REVISION				
REV	DESCRIPTION	DRAWN	APPR	DATE
IR	Initial Registration	I.C.KIM		2014.08.19.
1	[설변No.202012-0002] O-RING 빠짐 개선 안착부 금형수정	I.C.KIM		2020.12.07.
2	[설변No.202101-0003] O-RING 빠짐 개선 안착부 0.1mm Ground Boss 추가	S.Y.EUN	I.C.KIM	2021.01.20.

TITLE: N50 CABLE JS-4H MF141

A4 | DWG NO. CN03960-7/2 | REVISION 2 | SHEET 1 of 1

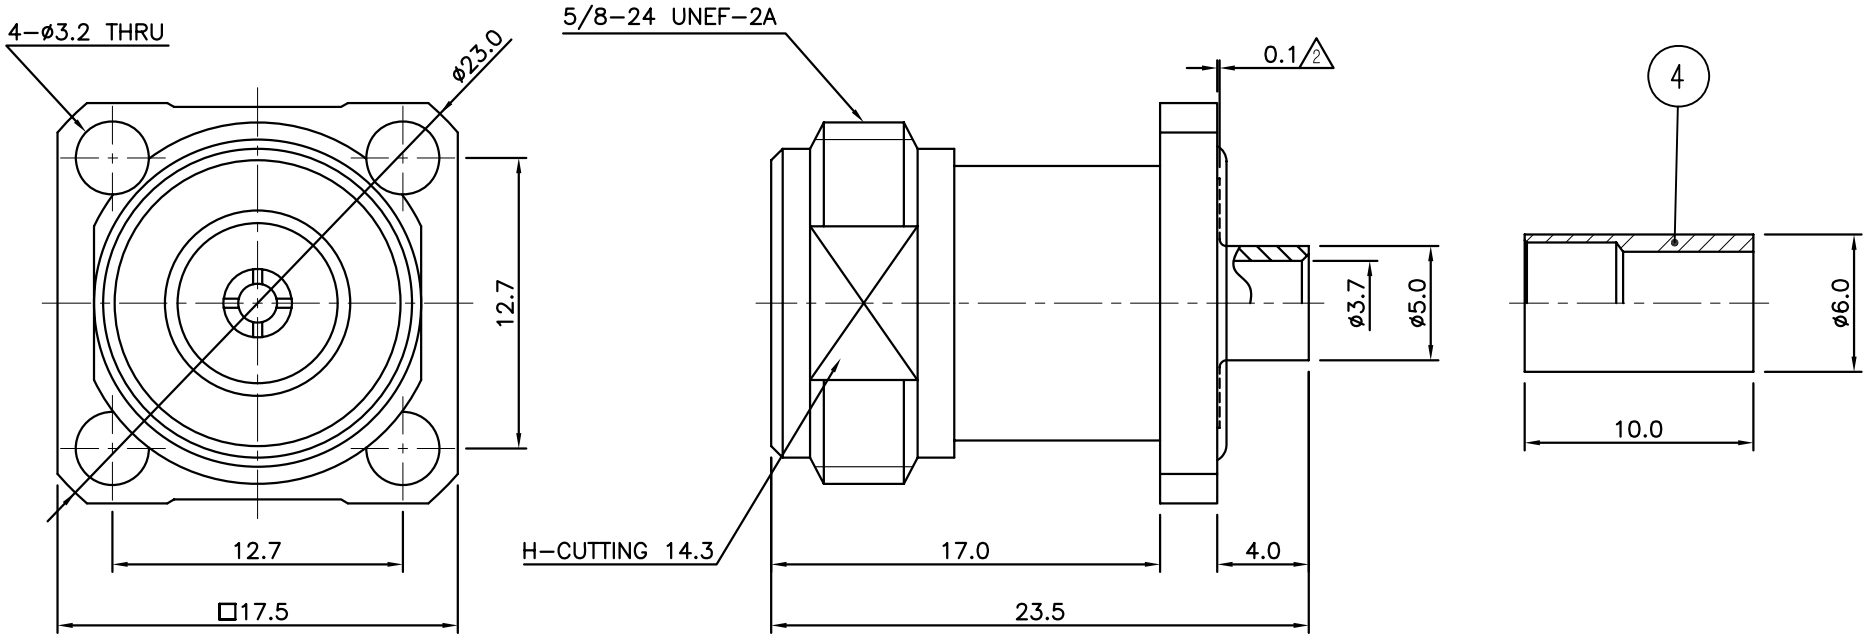
NO.	DESCRIPTION	Q'TY	MATERIAL	PLATING	CODE
	6	INSULATOR	1	MBsBD C3604BD-F		DIN01966-N/1
1	5	GASKET	1	SILICONE Rub ~~NBR~~		DGK00257-N/2 ~~DGK00257-N/1~~
	4	FERRULE	1	MBsBD C3604BD-F	Nickel Plate	DFE00162-5/1
	3	CONTACT	1	BeCu C17300	Gold Plate	DCT02526-5/1
2 1	2	BODY	1	MBsBD C3604BD-F	Nickel Plate	DBD02997-5/2 ~~DBD02997-5/1~~
1	1	BODY	1	ZnDC	Nickel Plate (3~4㎛)	DBD02992-5/3 ~~DBD02992-5/1~~
